©Kawasaki Motors Corp 1974 Printed in USA

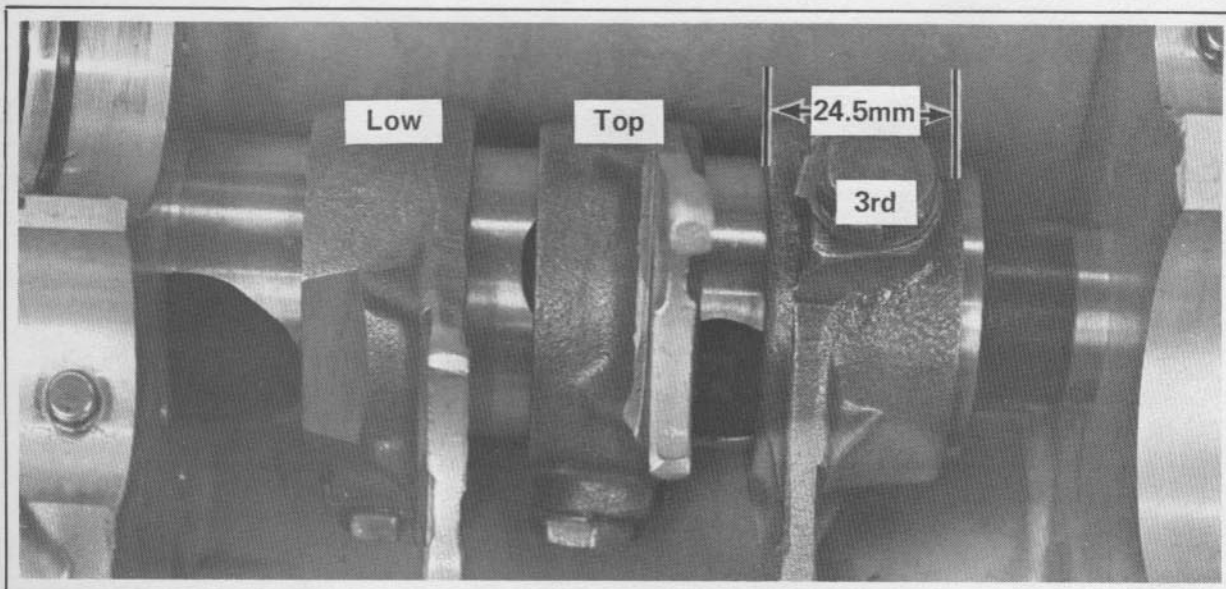
The second problem has been countermeasured by widening the base of the shift fork to keep the fork more rigid on the shift drum. This wider fork is supported on both sides of the groove on the shift drum.

The new fork is easily recognized by its wide base.

DESCRIPTION	OLD PARTS		NEW PARTS		INTER- CHANGE	EFFECTIVE I.D.
	P/N	REMARKS	P/N	REMARKS	OLD↔NEW	
3rd gear shift fork H1	13140-013	21.0mm wide	13140-064	24.5mm wide		KAE-87023
3rd gear shift fork H2	13140-048	21.0mm wide	13140-065	24.5mm wide		H2E-31941

SWINGING ARM PIVOT SHAFT:

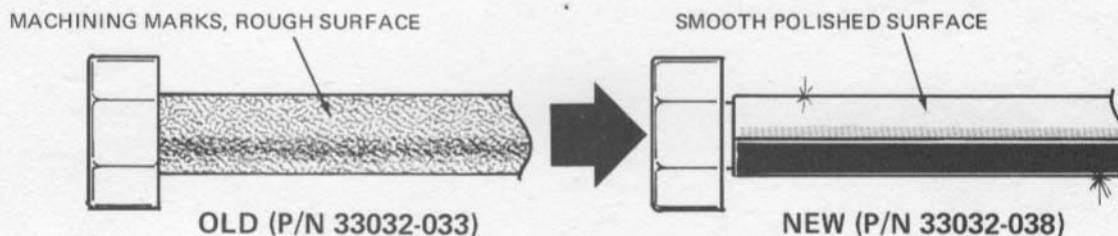
The H2A pivot shaft has a smooth polished surface as compared to the H2 pivot shaft which has a semi-rough machined surface.

BUSHINGS:

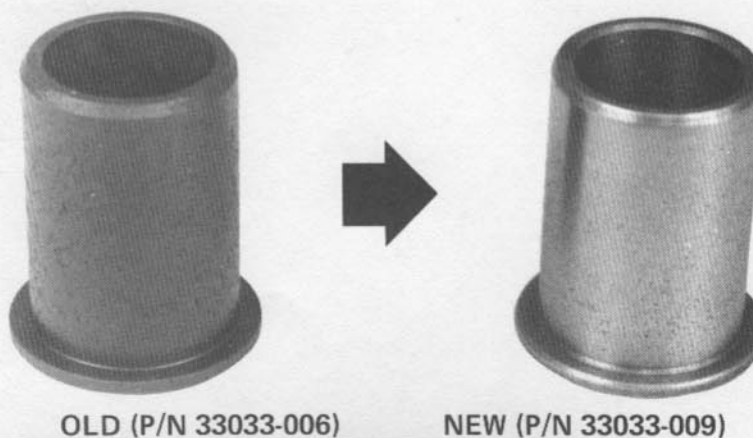
The H2 uses phenolic bushings made of a cotton or asbestos filler bonded with a phenolic resin. The H2A uses sintered iron bushings for better resistance to wear and fracture. The sintering process produces a spongelike structure in the metal making it capable of absorbing 20 percent of the total volume with lubricant. This type of bearing is ideal in areas where lubrication is infrequent.

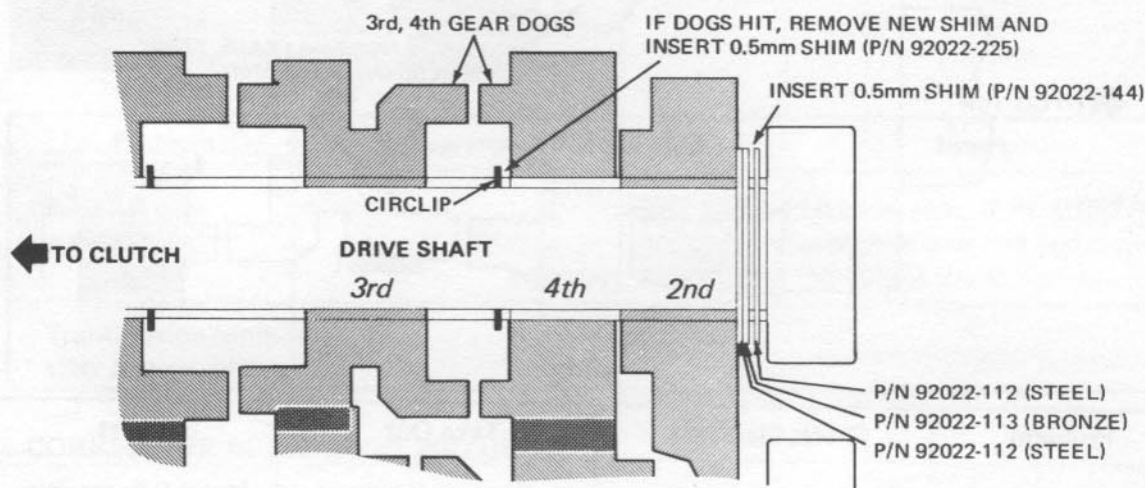
On early H1 and H2 models, there have been problems of gear engagement resulting from excessive play in the stationary gears on both the drive and output shafts.

Several shims have been added on both output and drive shafts in order to eliminate specific problems. These corrections have been applied to all H1's from engine numbers KAE-59017 and up, and to all H2's from the beginning of production.

B. CORRECTIVE ACTION FOR 5TH GEAR:

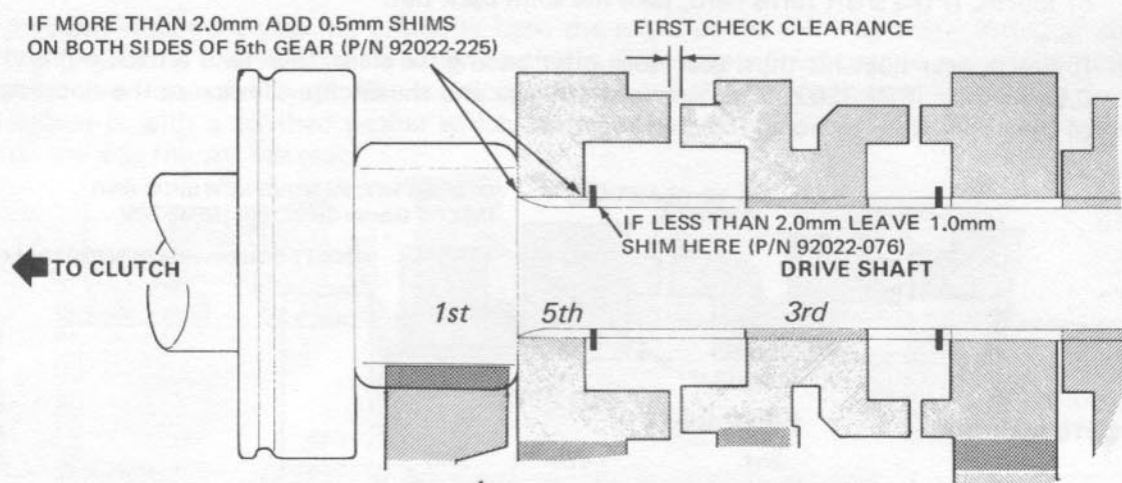
1. To eliminate jumping out of fifth gear, measure the clearance between fifth and third gear dogs on the drive shaft. If the clearance is over 2.0mm, remove the factory installed 1.0mm shim (P/N 92022-076) between fifth gear and the circlip, and add a 0.5mm (92022-225) shim on either side of fifth gear. This moves fifth gear 0.5mm closer to the slider gear, assuring a more positive engagement. If the clearance is less than 2.0mm between dogs on the two gears, then leave the 1.0mm shim where it is.

C. CORRECTIVE ACTION FOR 1ST GEAR:

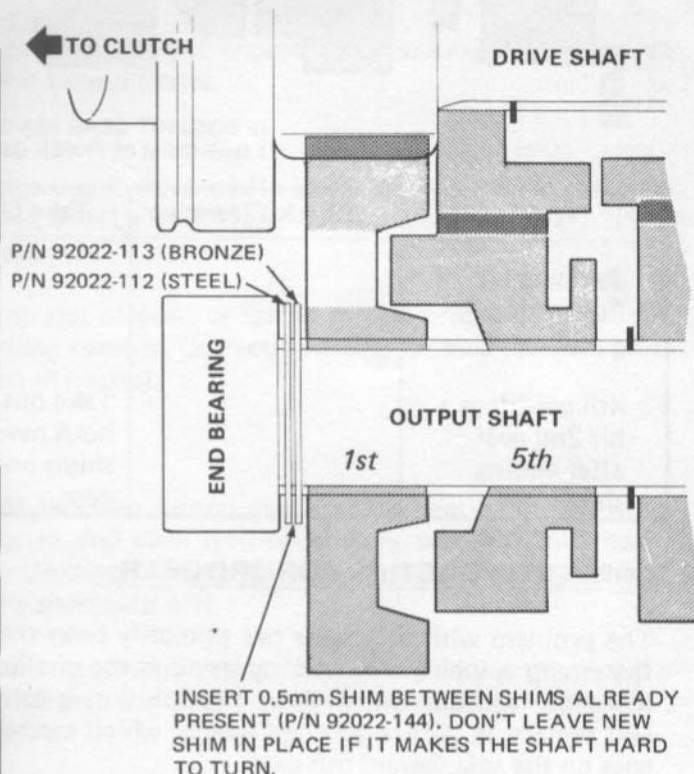
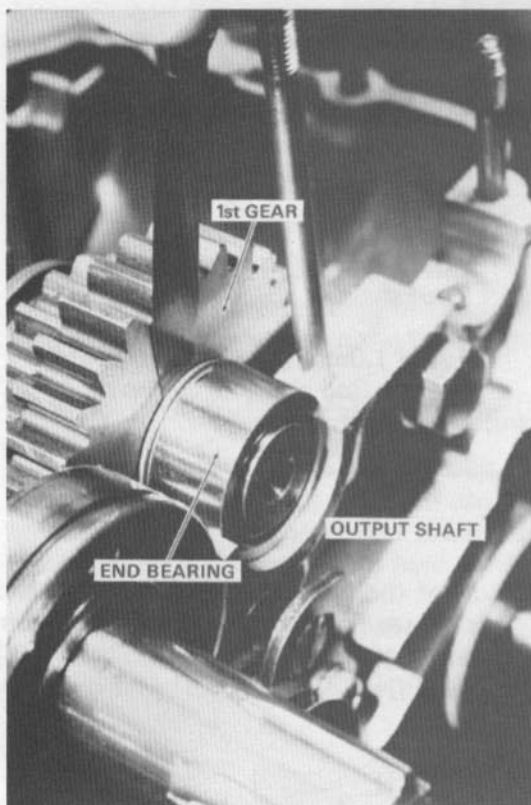
To correct poor engagement of 1st gear, insert an 0.5mm shim (P/N 92022-144) between first gear and the end bearing on the output shaft. This is in addition to the shims already present (P/N 92022-112, -113). This moves 1st gear slightly closer to the slider gear and eliminates play which may have contributed to jumping out of gear. If adding this shim makes the output shaft hard to turn, then take it back out.

Problem	Check Clearance	Take Out	Insert
Poor 1st gear engagement.			Add 0.5mm shim (P/N 92022-144) between first gear and end bearing on the output shaft.
Transmission binds after adding shim.		Take out new shims.

D. CORRECTIVE ACTION FOR 2ND GEAR:

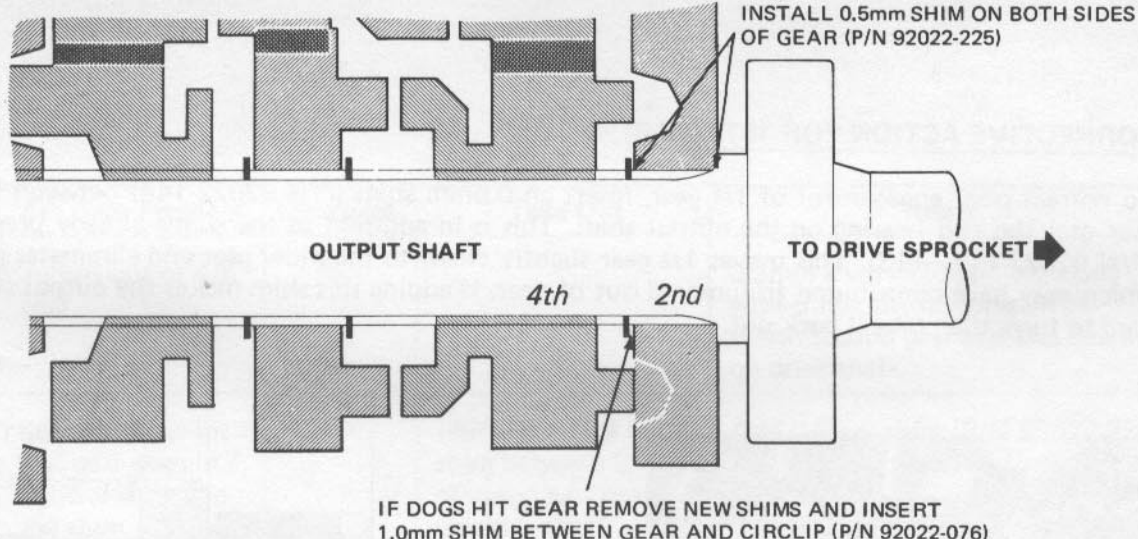
To eliminate play at second gear on the output shaft, install a 0.5mm washer (P/N 92022-225) on both sides of the gear. This moves the gear slightly closer to the fourth gear slider as well as reducing play. If the dogs on fourth gear hit second gear after the shims are added, remove both new shims and add a 1.0mm shim (92022-076) between second gear and the circlip. This will keep the dogs from hitting, while eliminating play at second gear.

Problem	Check Clearance	Take Out	Insert
Jumping out of 2nd gear.			Add 0.5mm shim (92022-225) on both sides of 2nd gear on the output shaft.
4th gear dogs hit 2nd gear after adding shims.		Take out both new shims on 2nd gear.	Add 1.0mm shim (92022-076) between 2nd gear and circlip on output shaft.

E. CORRECTIVE ACTION FOR 3RD GEAR:

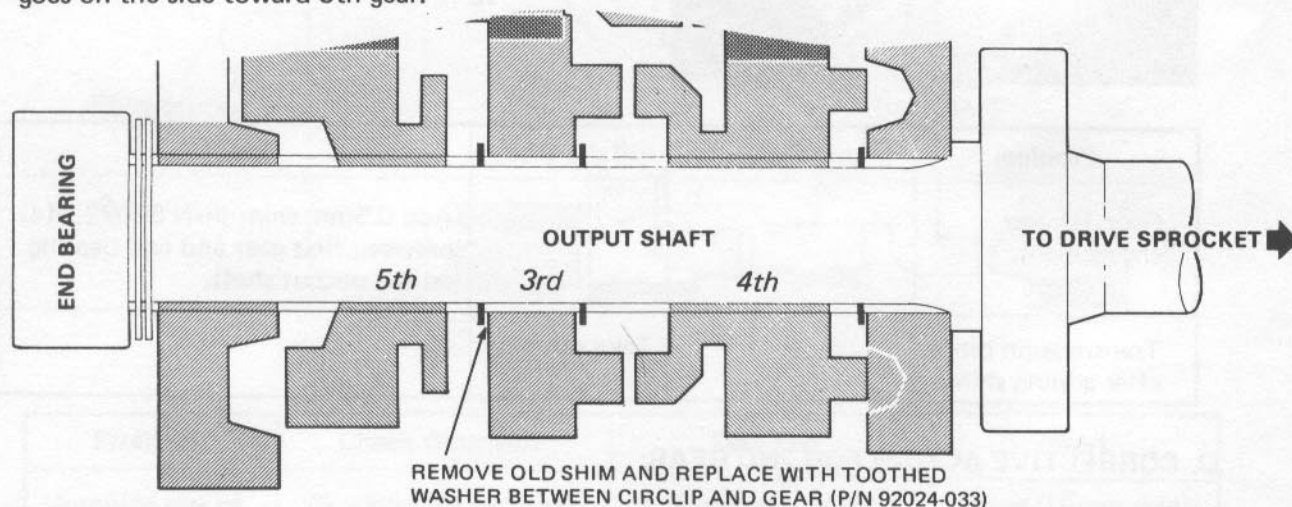
The problem with third gear has primarily been the result of the shim between 3rd gear and the circlip spinning and wearing through the circlip. This causes third gear to move away from the slider and hop out of gear. The solution is to remove the standard shim (P/N 92022-076) and replace it with a toothed washer which cannot rotate (P/N 92024-033). The new washer goes on the side toward 5th gear.

Problem		Take Out	Insert
Jumps out of 3rd gear.		Remove 1.0mm shim between 3rd gear and circlip on output shaft.	Insert 1.0mm toothed thrust washer (P/N 92024-033) between 3rd gear and circlip (5th gear side).

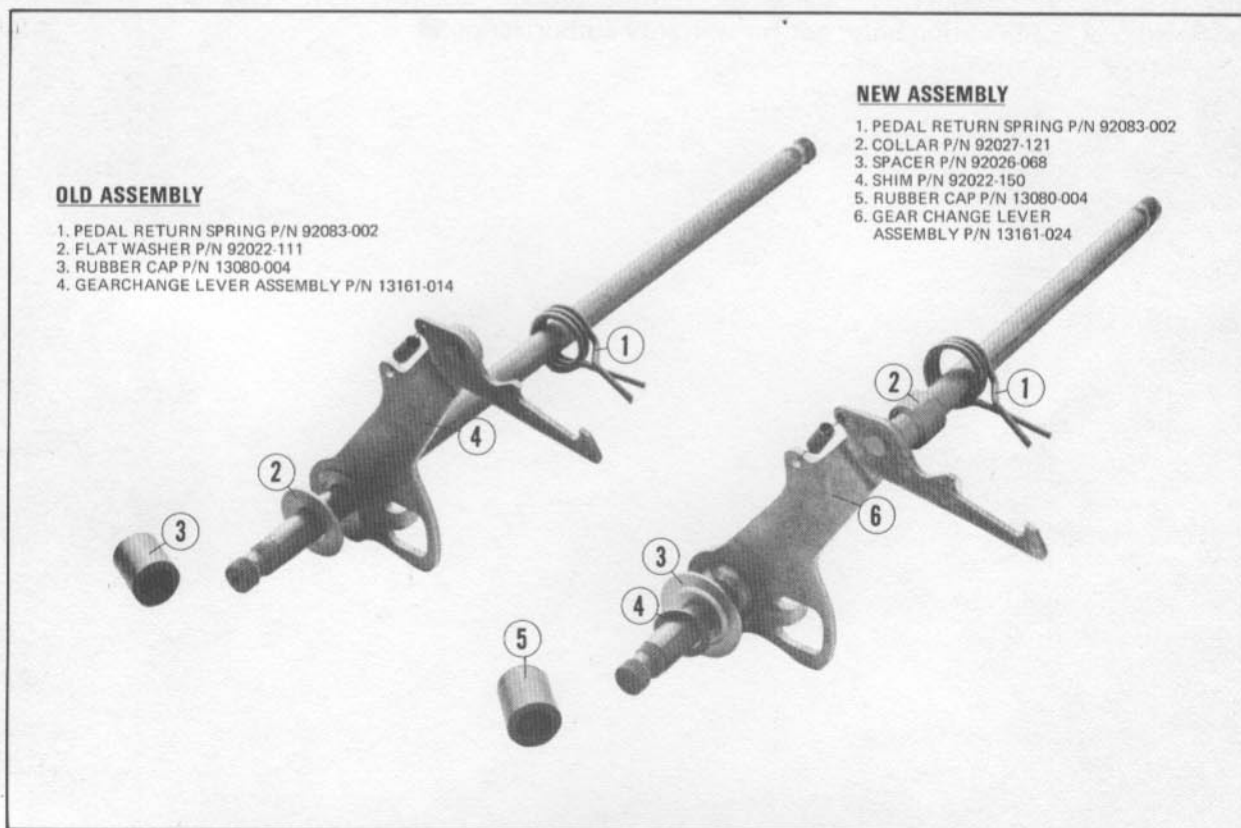
On the early H1 models, the gear change lever assembly consisted of a toothed lever staked to a rod. This construction sometimes loosened up, causing sloppiness in shift lever movement. This contributed to missed shifts, and sometimes led to transmission damage.

An additional point of confusion comes from a variation in the assembly as pictured in the parts manuals for H1B and H1D.

To remedy this problem, a new gear change lever assembly was designed for the H1 and H2. The new unit is welded, rather than staked, and includes a collar inside the pedal return spring, a spacer, and a shim outside the spacer.

CAUSE:

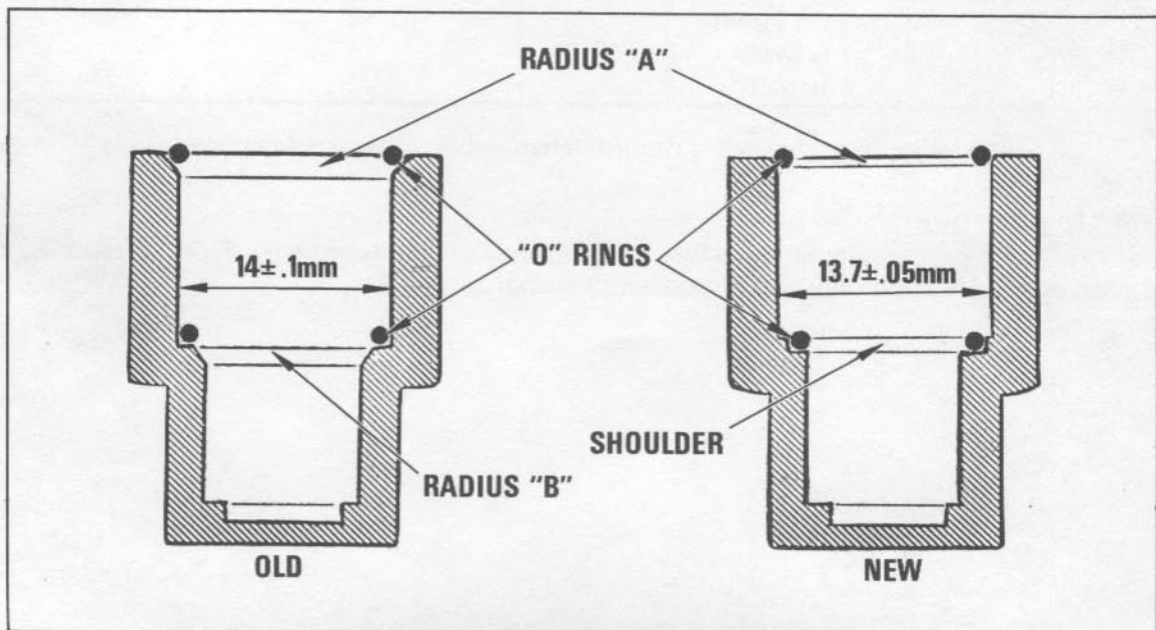
This problem has been traced to faulty O-ring seating in the oil pump end cover. After installation, the two O-rings inside the cover shrink approximately .1 to .2mm in diameter. This shrinkage allows oil to seep around the seals and into the end cover chamber. From this point, the excess oil is pumped to the right cylinder which is serviced by the end cover orifice, resulting in smoking and premature sparkplug failure.

- A. Radius "A" has been decreased in depth to give the O-rings less "squish" space, making a tighter seal.
- B. Radius "B" has been eliminated altogether, improving the seal at this point.
- C. The internal diameter of the chamber has been decreased from $14 \pm .1\text{mm}$ to $13.7 \pm .05\text{mm}$ to compensate for O-ring shrinkage.
- D. A slight shoulder has been added to the base of the new chamber to further compress the O-ring.

CORRECTION:

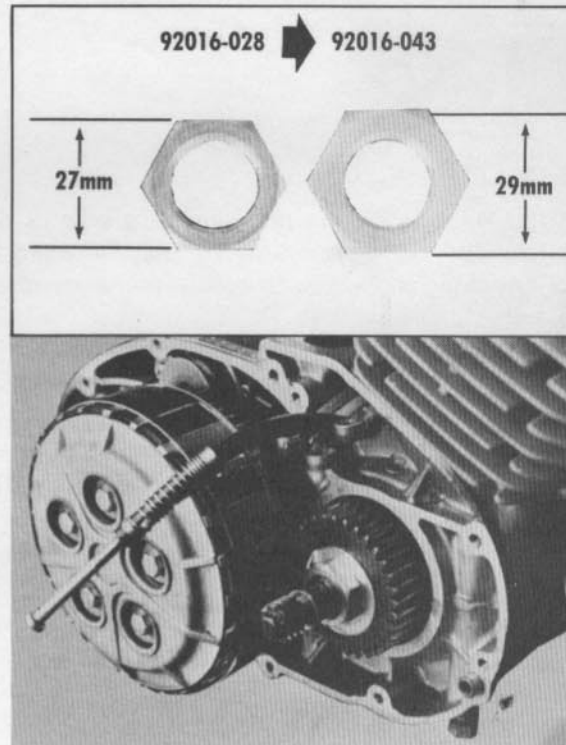
A new larger nut, with a 29mm O.D., is used to increase the lockwasher crush area and eliminate washer extrusion. The larger nut has been installed in all H2's after engine number H2E-05228.

DESCRIPTION	OLD PARTS		NEW PARTS		INTER-CHANGE	EFFECTIVE I.D.
	OLD P/N	REMARKS	NEW P/N	REMARKS	OLD ↔ NEW	
Primary Pinion Nut	92016-028	27mm	92016-043	29mm		H2E-05228

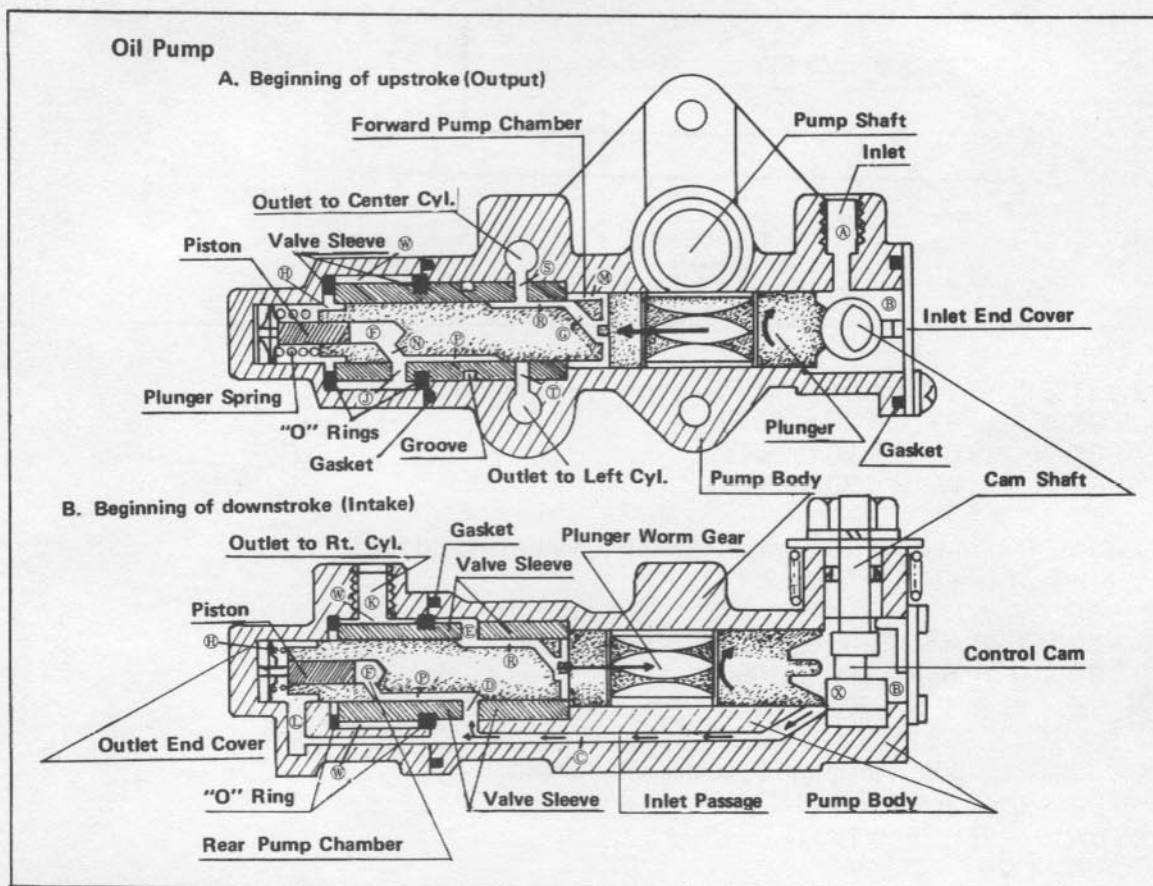
- A. Page 20, Paragraph e.
The connecting rod small end play service limit should be 0.0039 in. (0.10mm).
- B. Page 28, Second Column. Line five should read:
"the clutch hub. Thus, the drive train is as"
- C. Page 44. Diagram 182 should be corrected to match the following diagram:

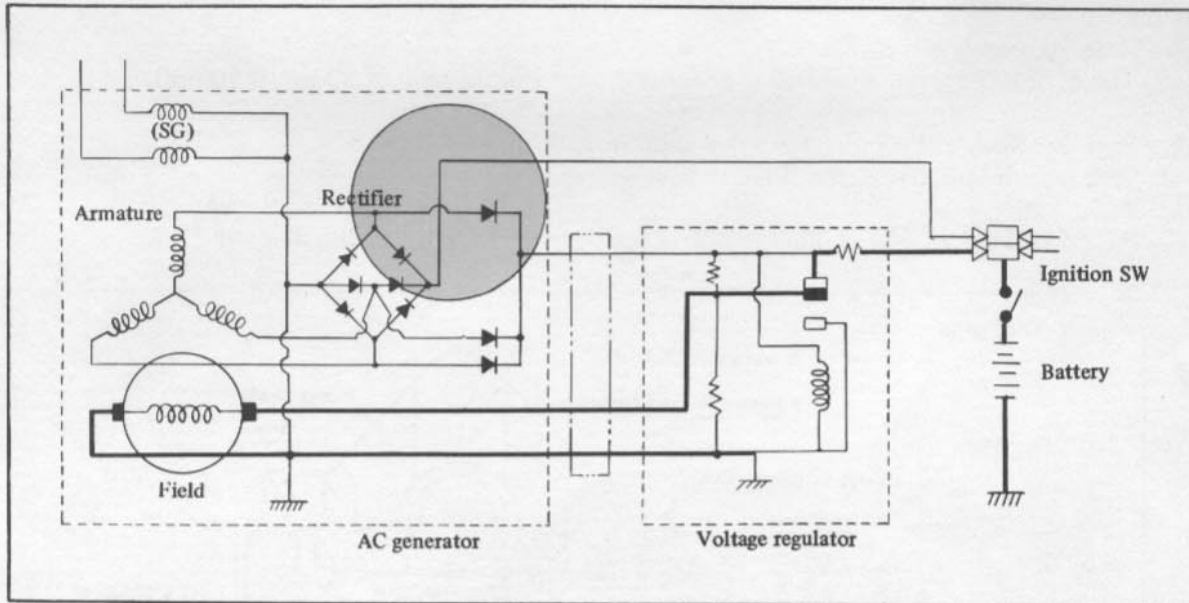
- D. Page 45, First Column. Line eleven should read:
"follower coincides with the center cylinder outlet"
- E. Page 45, First Column. Line twenty-one should read:
"around to the outlet K and from there to the right"
- F. Page 45, Second Column. Line twenty-eight should read:
"T" to the center on left cylinder outlet."
- G. Page 45, Second Column, Line twenty-eight should read:
"flows into space W to the engine right cylinder"
- H. Page 52, Table 21. H2 jet needle should be "5EJ15-3."
H2 measurement "A" should be "same as H1."

- I. Page 65, Table 31 Spring Length:
H2 Standard Rear Length should read "2.36 in. (60mm)"
H2 Service Limit Rear Length should read "2.48 in. (63mm)"
- J. Page 104, Diagram #399 should be corrected to match the diagram below:

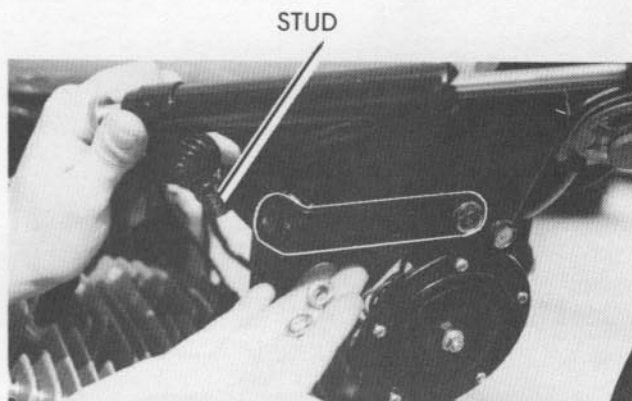
This reinforcing bracket must be installed to prevent flexing.

- A. Remove the nut and lockwasher holding the steering damper to the frame stanchion.
- B. Take out the right-hand bolt and lockwasher from the horn bracket.
- C. Fasten the long side of the reinforcing damper bracket to the frame with the horn bolt and lockwasher. **NOTE:** Use a plain washer (P/N 411B0800) over the new bracket and don't tighten the bolt completely yet.
- D. Hold the other end of the bracket over the stanchion, insert the damper stud, and install the lockwasher and nut. Now, tighten the horn bolt and the damper nut.
